Traffic Calming (Speed Humps) - Parkside Drive Study

Date: October 15, 2024

To: Toronto and East York Community Council

From: Director, Planning, Design and Management, Transportation Services

Attachment 1: Speed Hump Locations Plan - Indian Road from Grenadier Road to Geoffrey Street

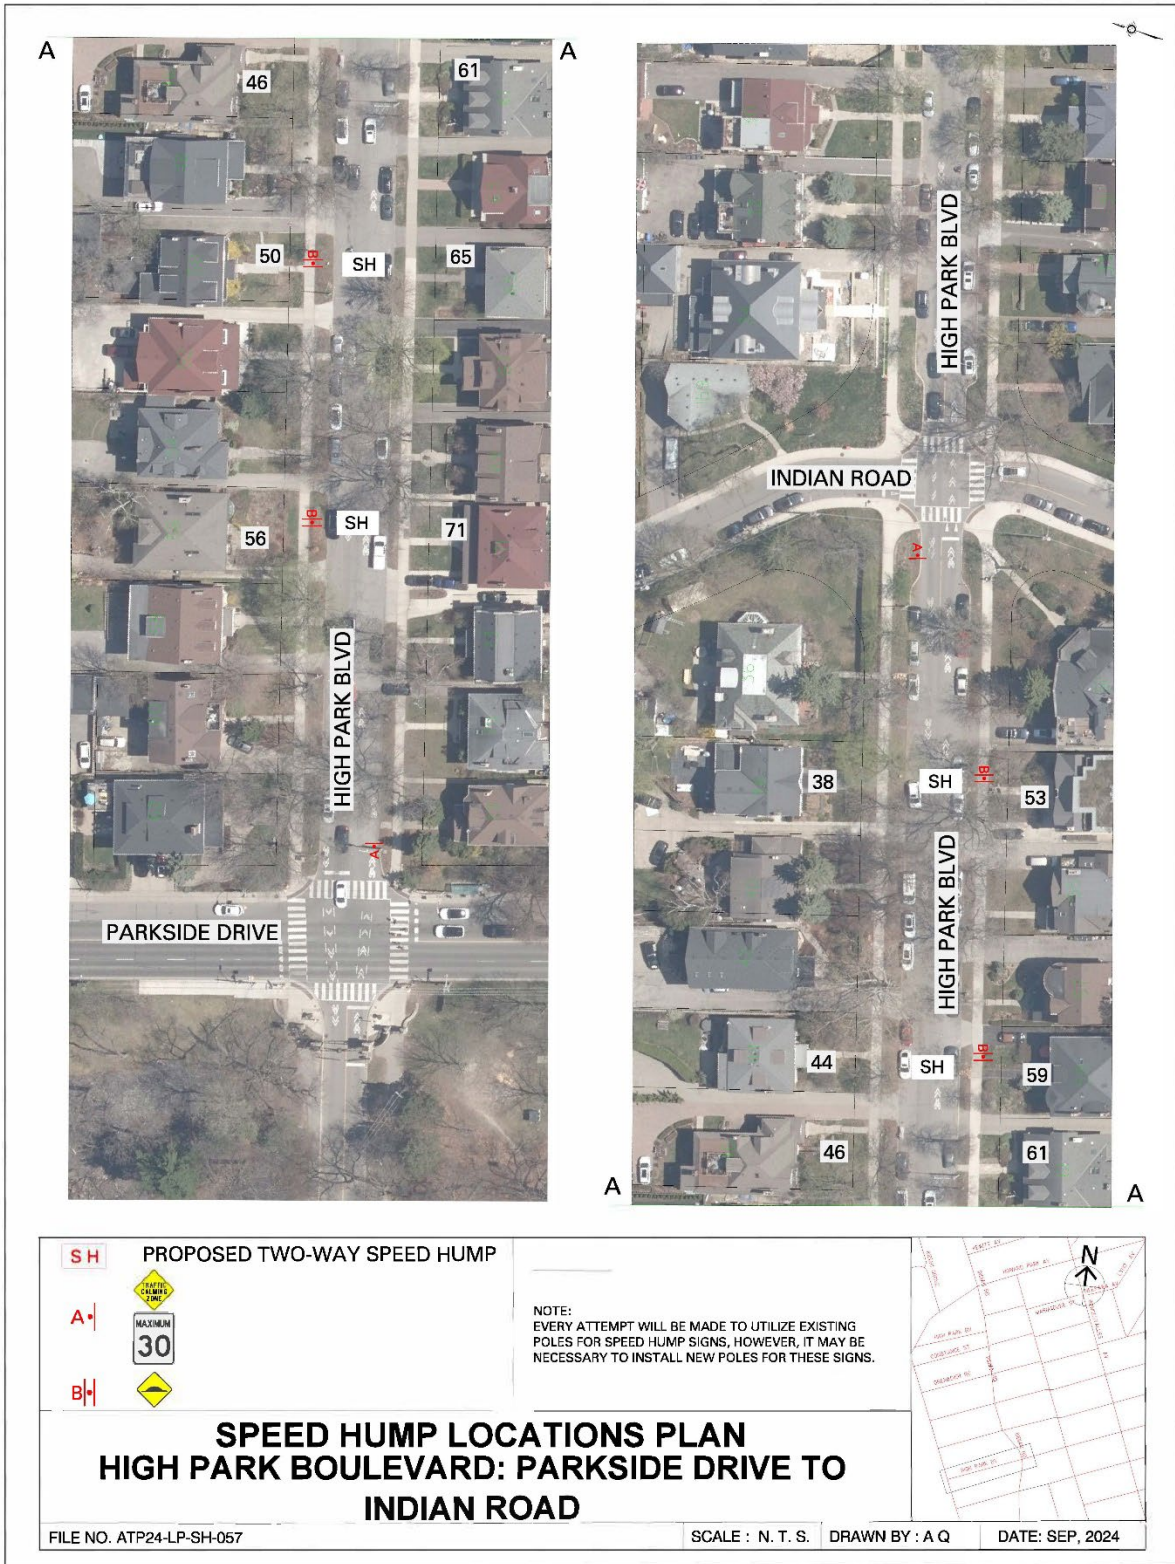
**RE: Indian Road between Bloor Street West and Garden Avenue, Speed Hump
Investigative Summary**

We are in receipt of and have reviewed the proposal for installation of traffic calming measures (speed humps) on **Indian Road between Bloor Street West and Garden Avenue** and provide the following comments.

Toronto Fire Services does not support this proposed speed hump installation as it may negatively impact service delivery. The physical restrictions imposed by speed humps have a greater impact on fire vehicles. Response time increases with every obstacle encountered responding to any emergency incident and the cumulative impact of several speed humps can increase responses times.

Toronto Fire Services is supportive of initiatives that improve safety for all citizens of and visitors to the City of Toronto. However, careful consideration must be given to accepting a delay to emergency response vehicles as a compromise to combat the risks presented by all vehicular traffic. Our recommendation is that non-physical measures be considered and evaluated to determine if desired results can be obtained without imposing a physical obstacle to emergency vehicles.

Attachment 3: Speed Hump Locations Plan - Ridout Street from Parkside Drive to Indian Road

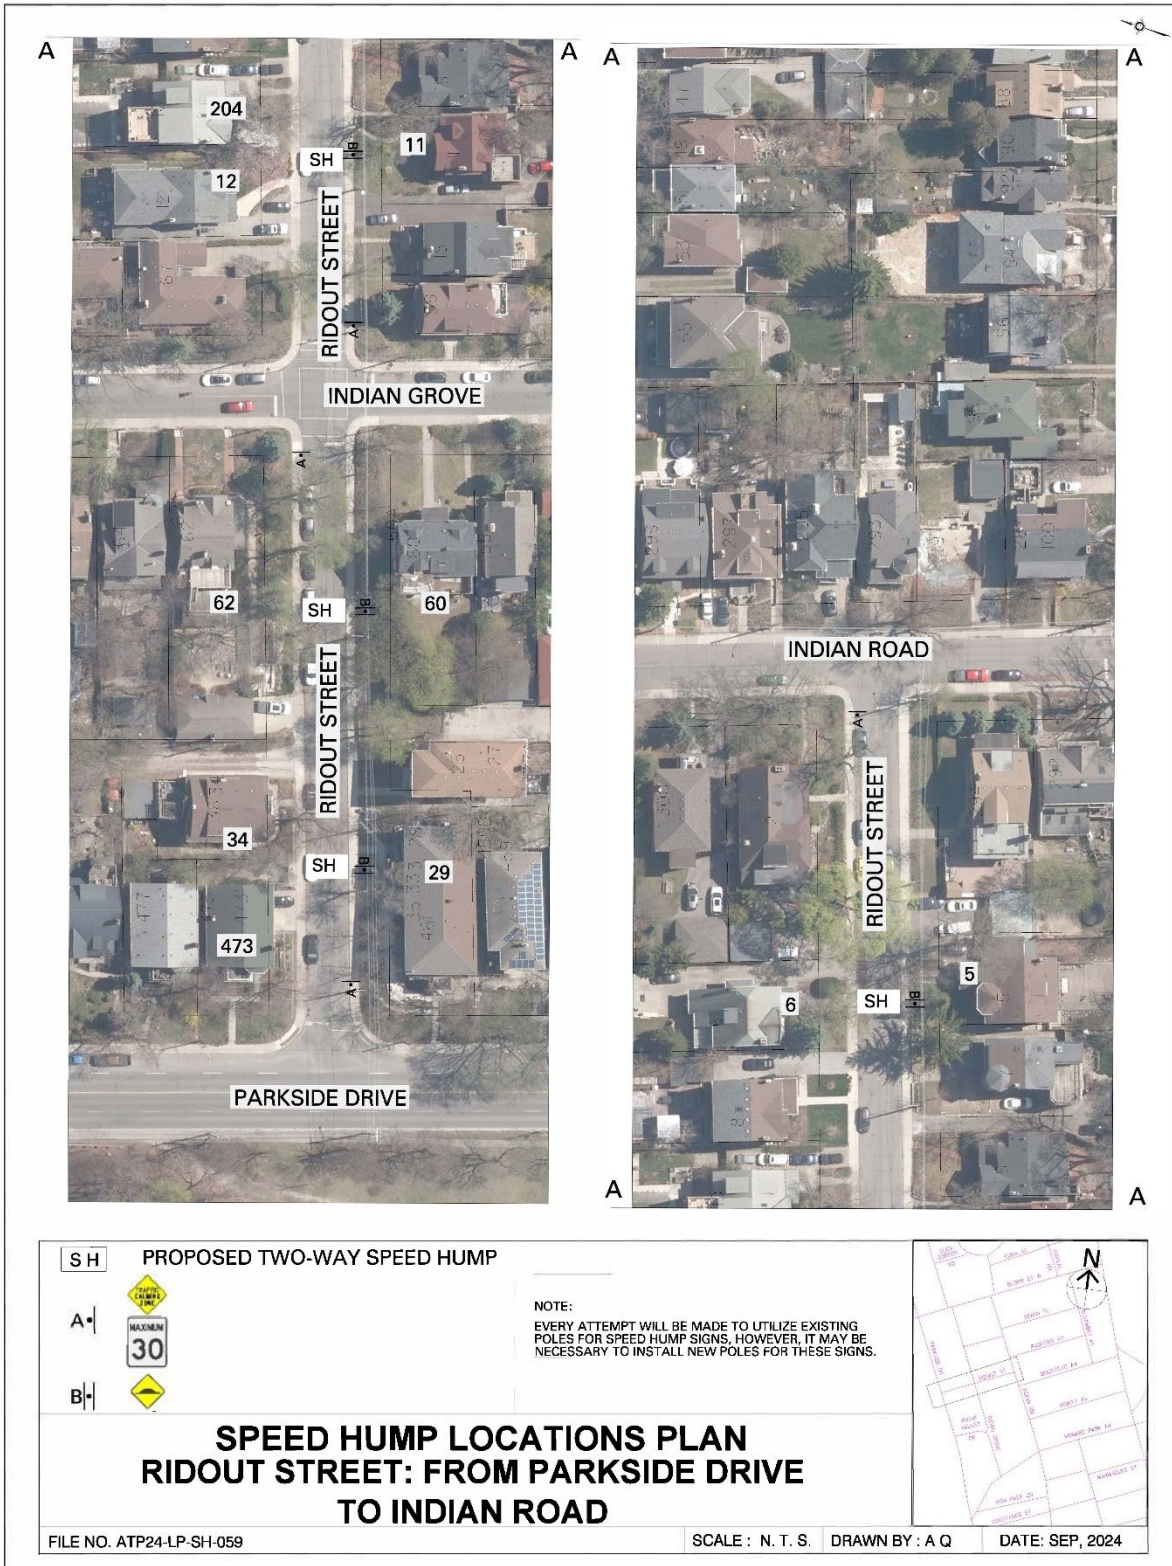
RE: Ridout Street between Parkside Drive and Indian Road, Speed Hump Investigative Summary

We are in receipt of and have reviewed the proposal for installation of traffic calming measures (speed humps) on **Ridout Street between Parkside Drive and Indian Road** and provide the following comments.

Toronto Fire Services does not support this proposed speed hump installation as it may negatively impact service delivery. The physical restrictions imposed by speed humps have a greater impact on fire vehicles. Response time increases with every obstacle encountered responding to any emergency incident and the cumulative impact of several speed humps can increase responses times.

Toronto Fire Services is supportive of initiatives that improve safety for all citizens of and visitors to the City of Toronto. However, careful consideration must be given to accepting a delay to emergency response vehicles as a compromise to combat the risks presented by all vehicular traffic. Our recommendation is that non-physical measures be considered and evaluated to determine if desired results can be obtained without imposing a physical obstacle to emergency vehicles.

Attachment 4: Speed Hump Locations Plan - Geoffrey Street from Parkside Drive to Indian Road

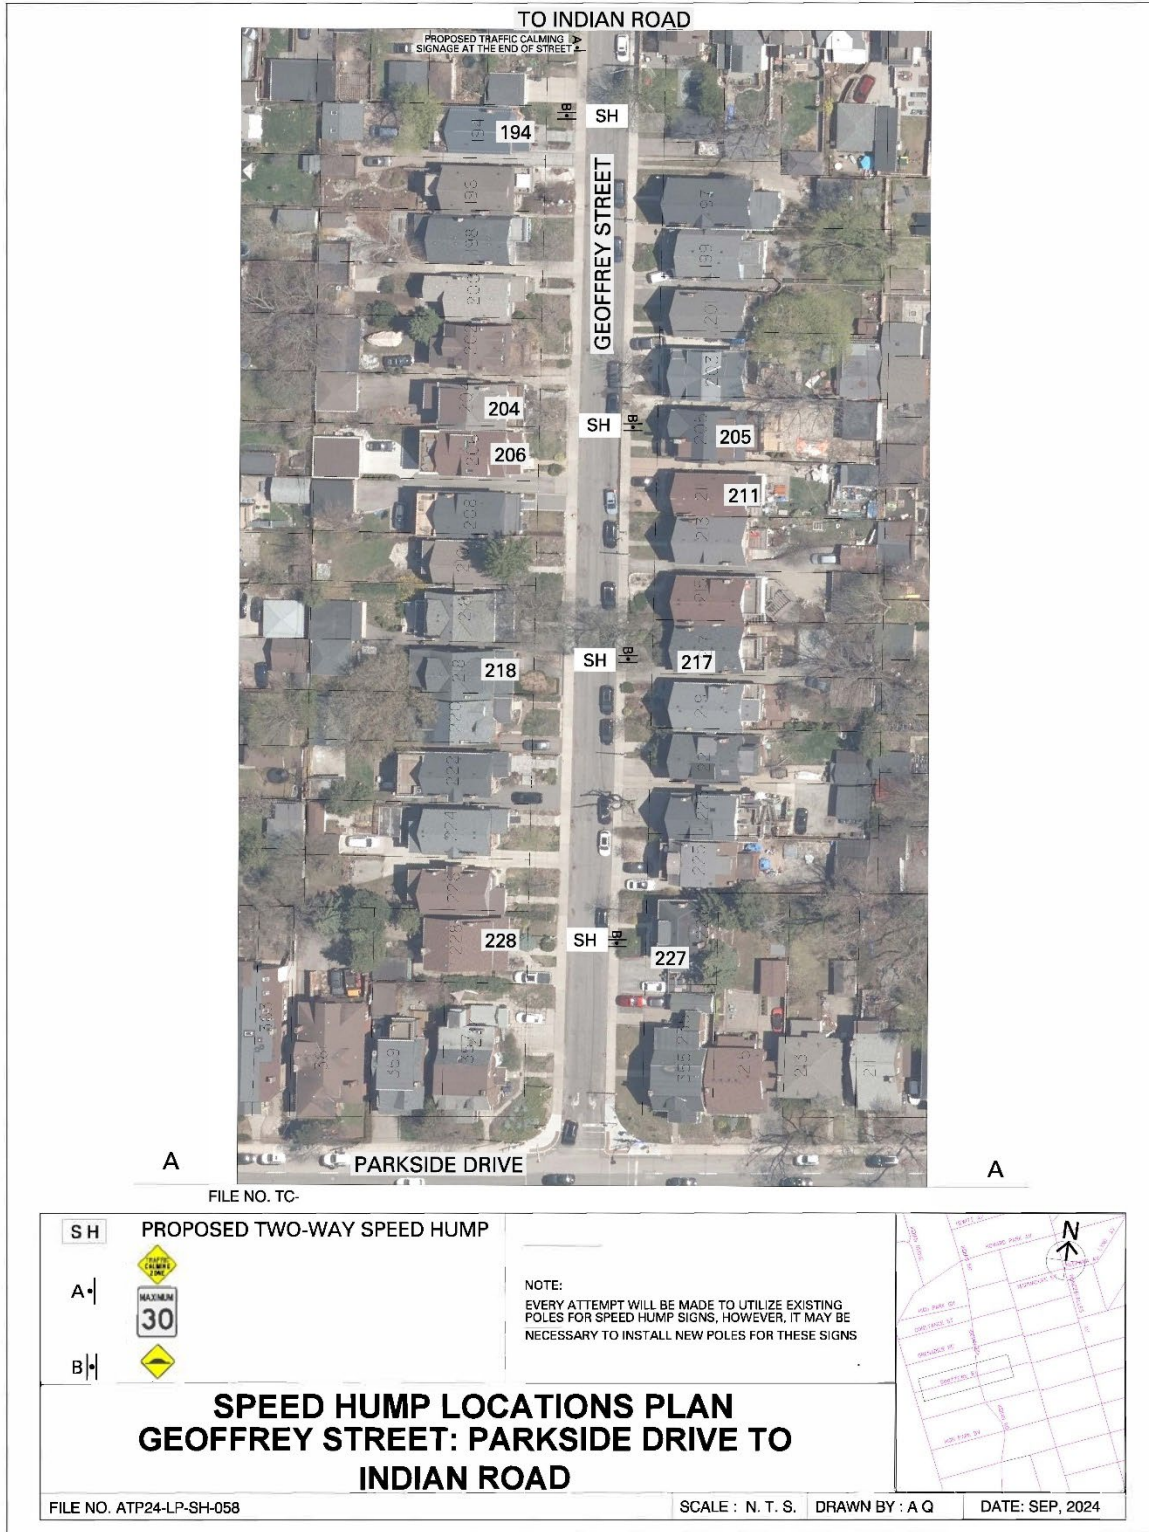
RE: Geoffrey Street between Parkside Drive and Indian Road, Speed Hump Investigative Summary

We are in receipt of and have reviewed the proposal for installation of traffic calming measures (speed humps) on **Geoffrey Street between Parkside Drive and Indian Road** and provide the following comments.

Toronto Fire Services does not support this proposed speed hump installation as it may negatively impact service delivery. The physical restrictions imposed by speed humps have a greater impact on fire vehicles. Response time increases with every obstacle encountered responding to any emergency incident and the cumulative impact of several speed humps can increase responses times.

Toronto Fire Services is supportive of initiatives that improve safety for all citizens of and visitors to the City of Toronto. However, careful consideration must be given to accepting a delay to emergency response vehicles as a compromise to combat the risks presented by all vehicular traffic. Our recommendation is that non-physical measures be considered and evaluated to determine if desired results can be obtained without imposing a physical obstacle to emergency vehicles.

Attachment 5: Speed Hump Locations Plan - Wright Avenue from Parkside Drive to Sunnyside Avenue

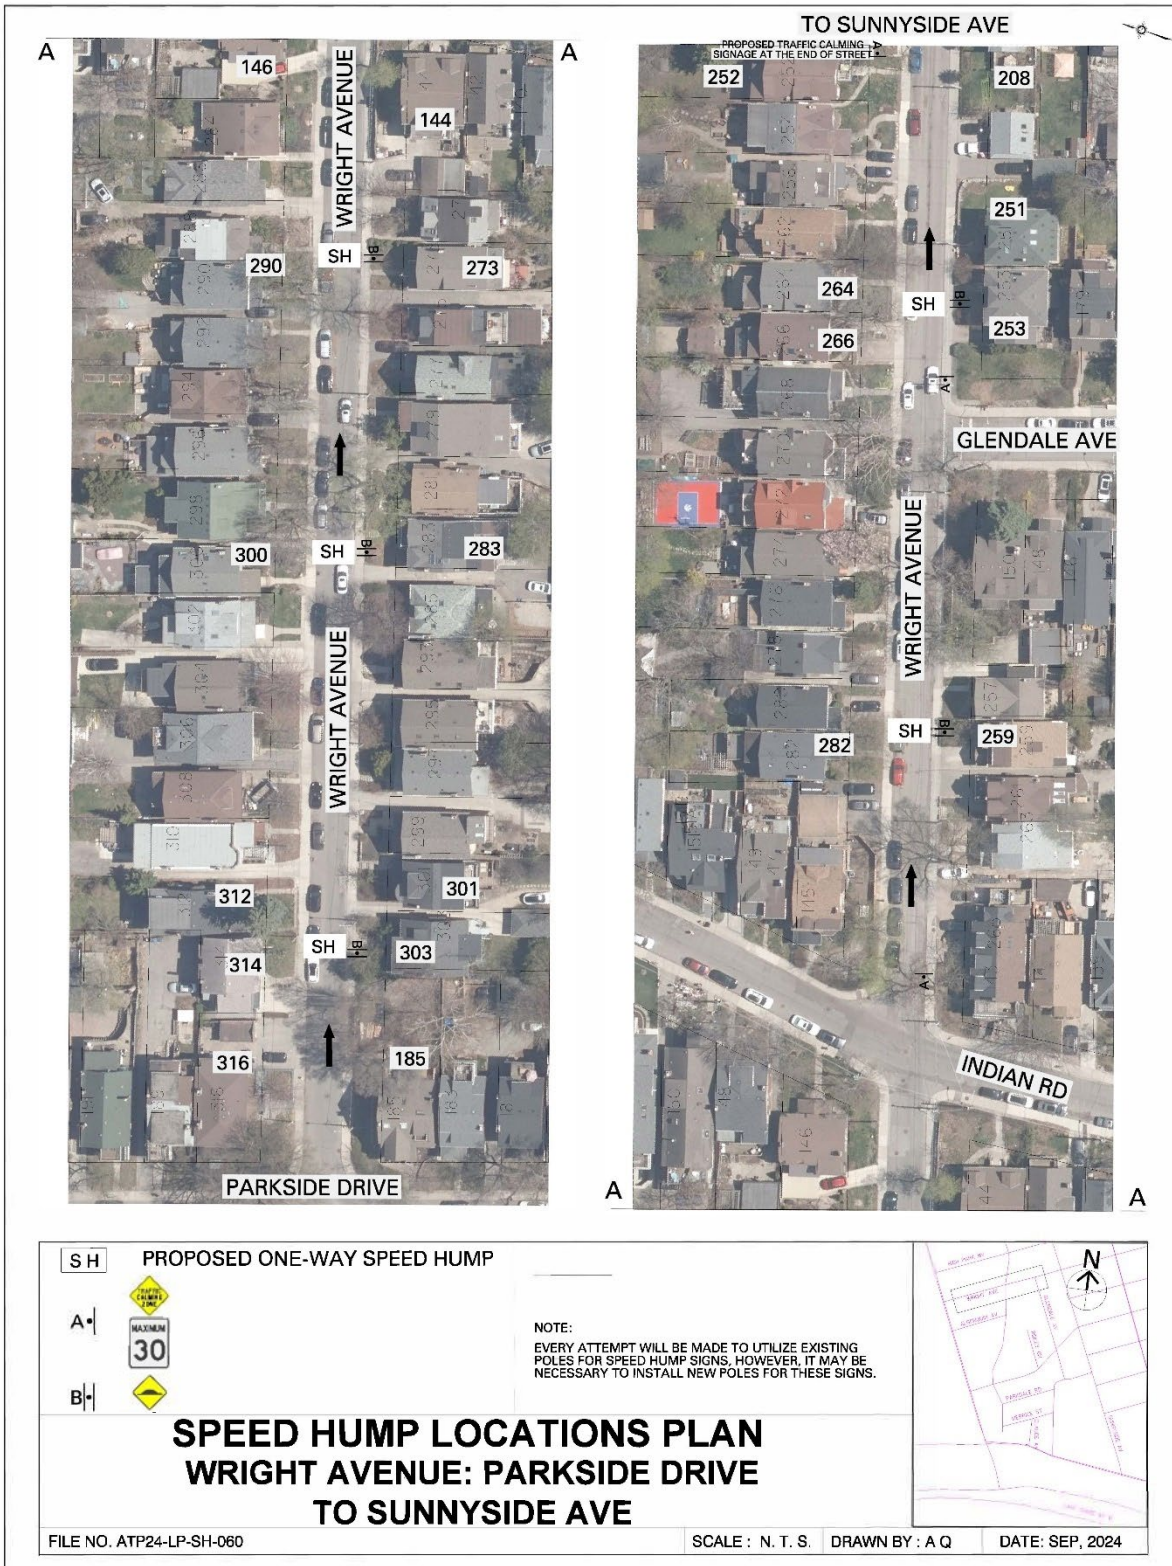
RE: Wright Avenue between Parkside Drive and Sunnyside Avenue, Speed Hump Investigative Summary

We are in receipt of and have reviewed the proposal for installation of traffic calming measures (speed humps) on **Wright Avenue between Parkside Drive and Sunnyside Avenue** and provide the following comments.

Toronto Fire Services does not support this proposed speed hump installation as it may negatively impact service delivery. The physical restrictions imposed by speed humps have a greater impact on fire vehicles. Response time increases with every obstacle encountered responding to any emergency incident and the cumulative impact of several speed humps can increase responses times.

Toronto Fire Services is supportive of initiatives that improve safety for all citizens of and visitors to the City of Toronto. However, careful consideration must be given to accepting a delay to emergency response vehicles as a compromise to combat the risks presented by all vehicular traffic. Our recommendation is that non-physical measures be considered and evaluated to determine if desired results can be obtained without imposing a physical obstacle to emergency vehicles.
